平陆县 100MW 农光互补光伏发电项目
监理工程师通知单

编号: ZHJL-JLTZ-PL-134

2024 年 9 月 25 日建设单位、监理单位及总包单位对西沟 6 号地块巡视检查中发现以下问题:
整改内容: 见下图

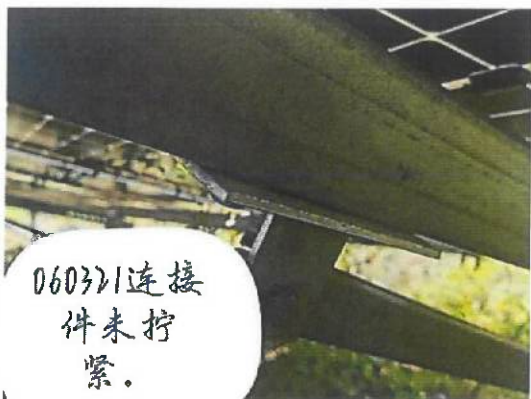
060321连接
件未拧
紧。

060321压块
未拧紧。

060321背拉
杆未拧
紧。

060321多于
檩条未裁
剪。

现场质量通病。
背拉杆未做好上下交叉。

060325压
块倾斜。

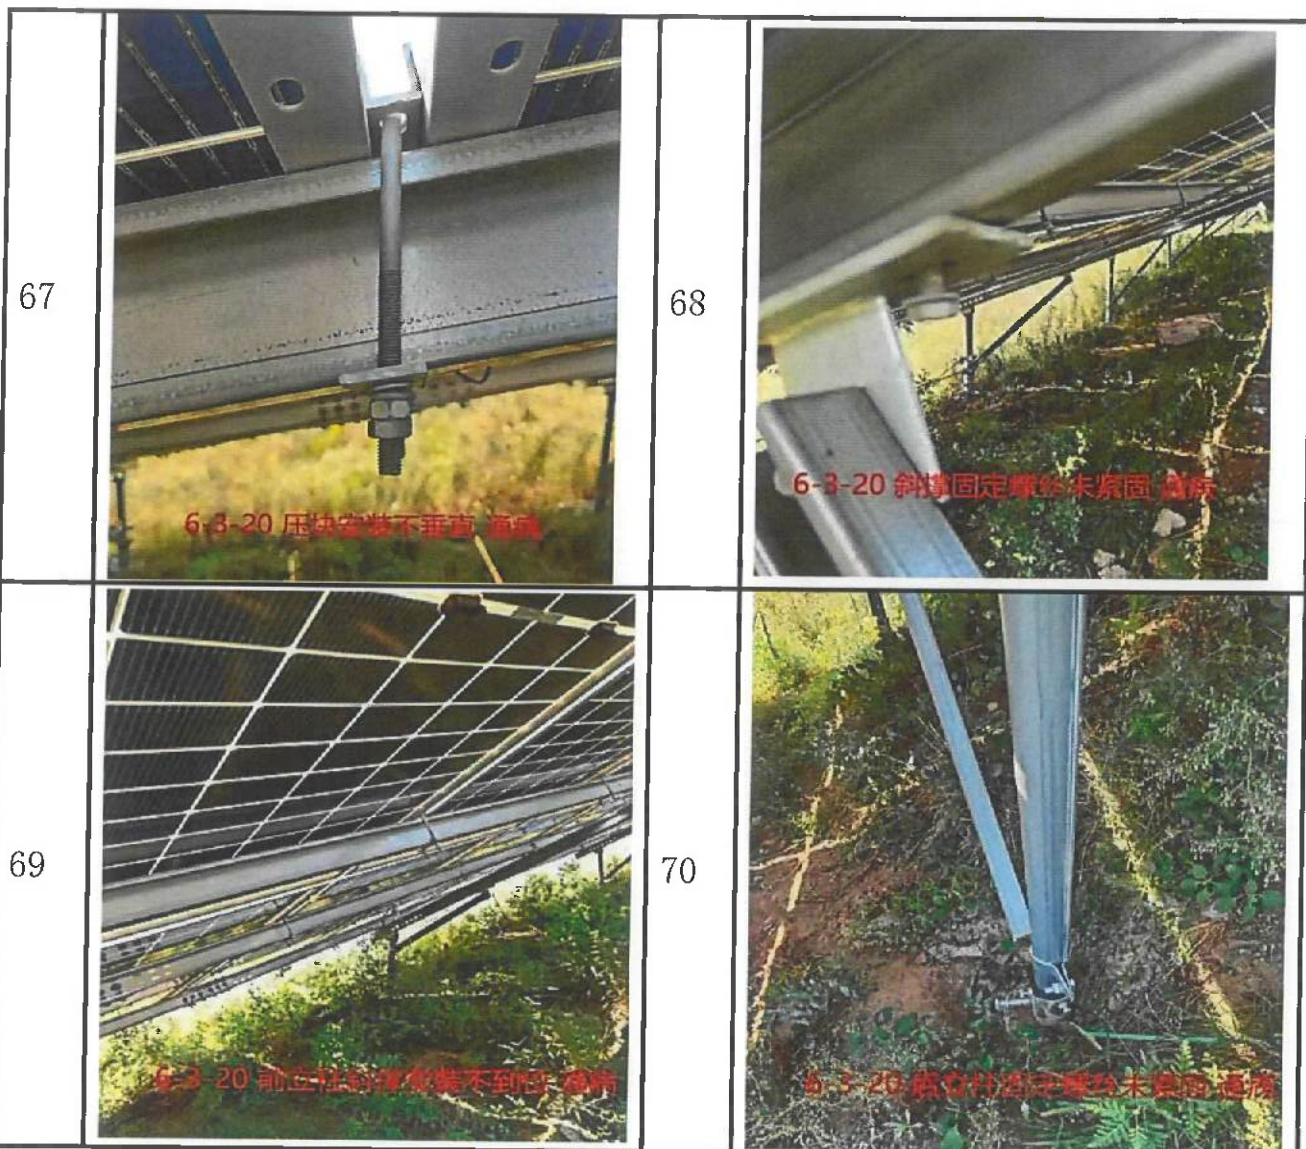
61	 6-4-2接地线未连接	62	 6号箱变围栏未做防腐措施 通病
63	 6-3-6 直流电缆管过密 通病	64	 6-3-6 直流电缆管过密 通病
65	 6-3-20 压块螺丝未紧固 通病	66	 6-3-20 压块螺丝未紧固 通病

以上通病需自查整改，其余地块需同步自查消缺。
